Peach Bottom Atomic Power Station, Units 2 and 3
Renewed Facility Operating License Nos. DPR-44 and DPR-56
NRC Docket Nos. 50-277 and 50-278

Subject: Response to Request for Additional Information Regarding Proposed Relief Request associated with the Common Emergency Service Water (ESW) System Piping for Peach Bottom Atomic Power Station, Units 2 and 3

**Response to Request for Additional Information Regarding
Proposed Relief Request Concerning I4R-56**

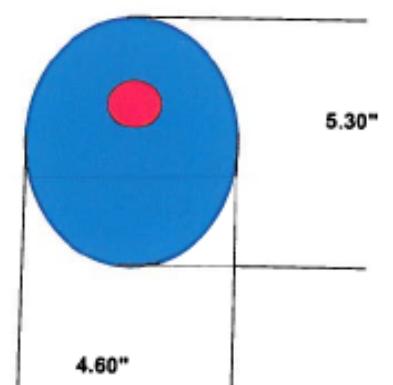
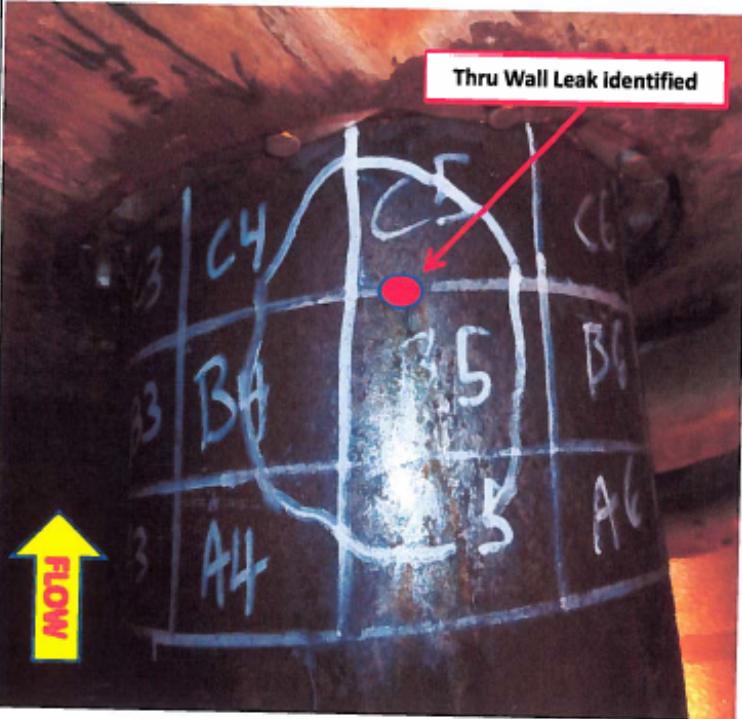
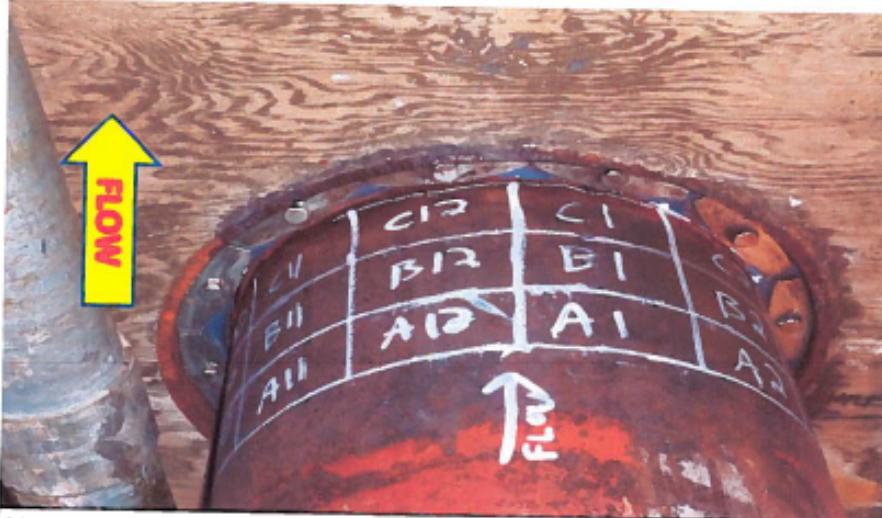
As discussed in Section 4.6 of NRC Office of Nuclear Reactor Regulation (NRR) Office Instruction LIC-102, "Relief Request Reviews," Revision 2 (ADAMS Accession No. ML091380595), the NRC staff may grant verbal authorizations of proposed alternatives when, due to unforeseen circumstances, licensees need NRC authorization before the staff is able to issue its written safety evaluation (SE). The relief request indicates that the leak was identified on May 3, 2015. However, the relief request was not submitted until July 29, 2015, with a requested review completion date of September 21, 2015. Due to the compressed schedule for this review, and other work currently in-house, the staff may have difficulty completing a written SE by the requested review completion date. As such, verbal authorization will be considered. Please explain the unforeseen circumstances associated with the delay in submitting the relief request from the time the leak was first identified.

Due to the location of the flaw within the ESW system, there were initial discussions as to whether or not the flaw was considered to be on common piping. The flow at the location of the flaw goes directly to the Unit 2 ECCS room coolers. Due to the flow path, the leak was originally considered a Unit 2 leak location. However, upon further review of plant piping and instrument drawings, and discussions between Site and Corporate Engineering, it was established that the leaking spool is classified as common to both units. Valve MO-2972 is the boundary between common piping and Unit 2 piping; therefore, given that the leak is upstream of the valve, it is classified as common.

In addition to the time required to correctly characterize the flaw location and condition, additional time was also dedicated to exhausting any possible means of repair to avoid the need for this relief request. This included attempts to quantify the leak rate through the degraded MO-2972 valve, as well as investigating repair methods via the use of a freeze seal, branch connection, and pipe sleeve, among others. The determination of feasibility for these repair options required input from various groups and in the end it was determined that none of the considered options were possible for repair of the leak. Concerns regarding the timeliness of this submittal have been entered into CAP to identify opportunities for improvement.

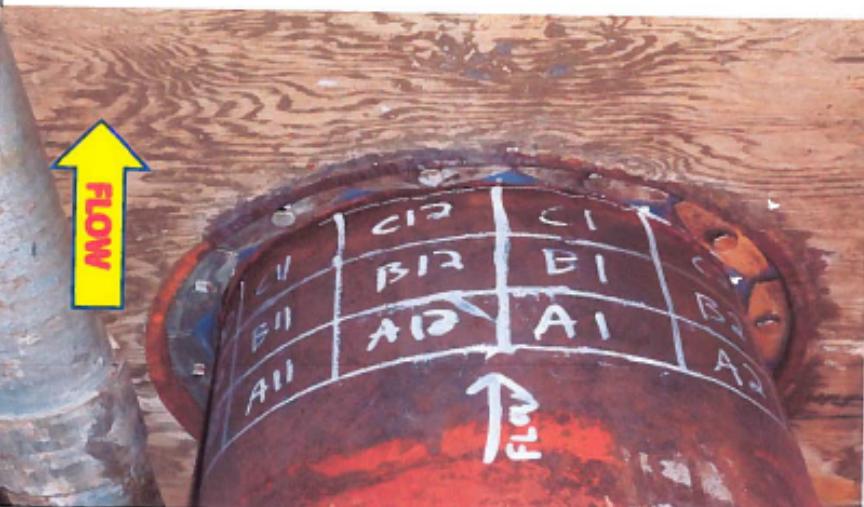
Section 5 of the relief requests states that "The assurance of quality and safety in the extended period of time between September 2015 and October 2016 is based on: ...5) Code Case N-513-3 required daily leak check and UT flaw examination every 30 days...." Provide the UT examination reports for examinations that have been performed subsequent to the UT examination detailed on pages 13 and 14 in Enclosure 2 of the relief request.

Successive 30-day UT inspections have been performed at the leak location. The exams have shown that no detectable growth in the flaw has been identified. All UT exams are provided in Enclosure 1.

COMMENTS: Area below Engineering Minimum Wall Thickness is .750" rounded, with the area below .328" approximately 4.6" x 5.30".
